## HISTORIC AND DESIGN REVIEW COMMISSION

**HDRC CASE NO:** 2020-409  
**ADDRESS:** 214 BARRERA  
**LEGAL DESCRIPTION:** NCB 717 BLK 14 LOT 4  
**ZONING:** RM-4, H  
**CITY COUNCIL DIST.:** 1  
**DISTRICT:** Lavaca Historic District  
**APPLICANT:** James Mullin/MULLIN JAMES M & MARY L  
**OWNER:** James Mullin/MULLIN JAMES M & MARY L  
**TYPE OF WORK:** Roof replacement  
**APPLICATION RECEIVED:** September 14, 2020  
**60-DAY REVIEW:** Not applicable due to City Council Emergency Orders  
**CASE MANAGER:** Huy Pham

The applicant is requesting a Certificate of Appropriateness for approval to replace the shingle roof with a standing seam metal roof. The applicant has proposed the new standing seam metal roof to feature vented ridge caps instead of a crimped ridge or a standing seam ridge sleeve and striated panels instead smooth panels.

**STRIATED**

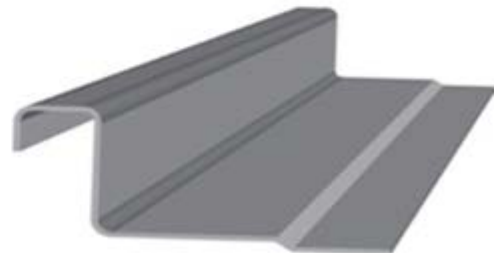
- d. STRIATION – The applicant has proposed to install striated panels instead of the standard specifications to feature smooth panels without striation or corrugation. The applicant has cited other structures with corrugation to which staff finds to be on new construction or installed prior to the adoption of the standard specifications for metal roofs and the materials inspection process (September 2017). Staff finds that the standard specifications per the Guidelines for Exterior Alterations 3.B.iv should be adhered to.

Staff recommends approval of the proposed roof replacement with the stipulation that the proposed roof feature smooth panels that are 18 to 21 inches wide, a crimped or double munched ridge seam, a standard galvalume finish and seams that are 1 to 2 inches in height.
